# J18 and J22 circuit breakers and bus protection

**RRP BUS 4.07**

**Revised proposal 2021–2026**

Figure 3.1 Risk monetisation model

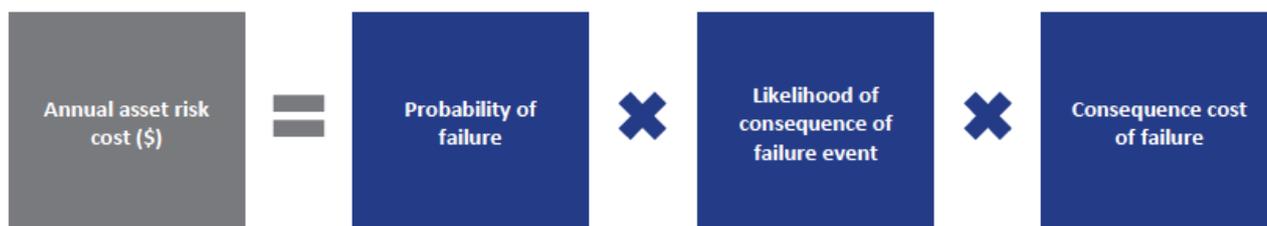
The AER commented that our risk monetisation overstated risk costs by adopting a likelihood of consequence which is 100 per cent in all cases, independent of the load and the time of failure. The AER concluded, therefore, that the case for our proposed expenditure was also overstated.

We understand the risk monetisation model, reproduced in figure 3.1, ordinarily distinguishes between the probability of failure; the likelihood of a failure event; and the consequence cost of a failure. However, it is reasonable to combine the latter two elements in a single variable, providing that the components are estimated

appropriately. Or stated alternatively, that these two variables are combined does not necessarily infer that risk costs are overstated, so long as the probability of the failure type is appropriate to the failure type, and not just the probability of a generic 'failure'.
